Product / Process Change Notification

N° 2019-127-A

Harmonization of shipping packaging for EconoPACK™ / EconoPIM™ / EconoDUAL™ and EconoBRIDGE™

■ **Econo3**

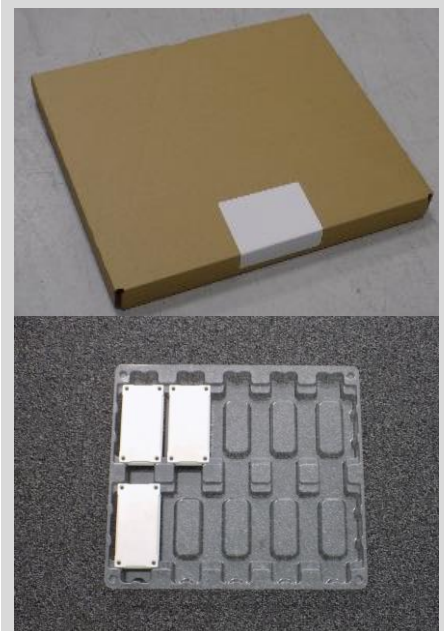
Harmonization of shipping packaging box to same box size across all Econo packages.

Size: 420 x 355 x 50 mm
Module per box: 10pcs
Orientation: Baseplate down

Size: 390 x 350 x 40 mm
Module per box: 10pcs
Orientation: Baseplate up

■ Econo4

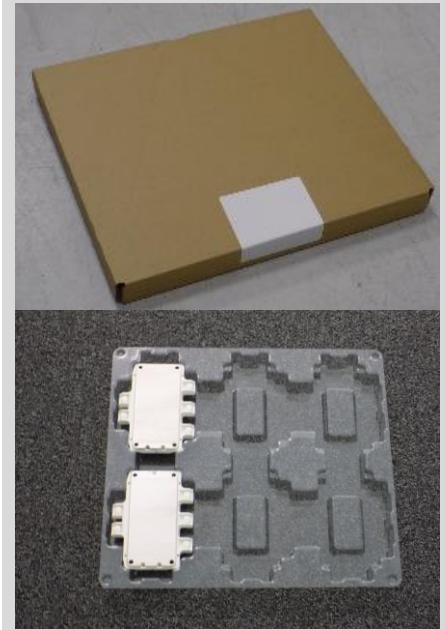
Size: 400 x 345 x 45 mm
Module per box: 6pcs
Orientation: Baseplate up

■ EconoDual3

Size: 510 x 400 x 40 mm
Module per box: 10pcs
Orientation: Baseplate up

Size: 390 x 350 x 40 mm
Module per box: 6pcs
Orientation: Baseplate up

Size: 390 x 350 x 40 mm
Module per box: 10pcs
Orientation: Baseplate up

■ EconoPACK+ B series

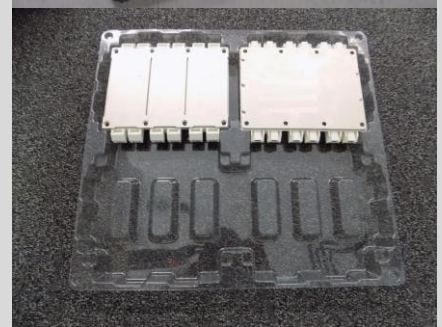
Size: 510 x 400 x 40 mm
Module per box: 4pcs
Orientation: Baseplate up

■ EconoPACK+ D series

Size: 400 x 235 x 90 mm
Module per box: 4pcs
Orientation: Baseplate up

Size: 390 x 350 x 40 mm
Module per box: 4pcs
Orientation: Baseplate up

Size: 390 x 350 x 40 mm
Module per box: 4pcs
Orientation: Baseplate up
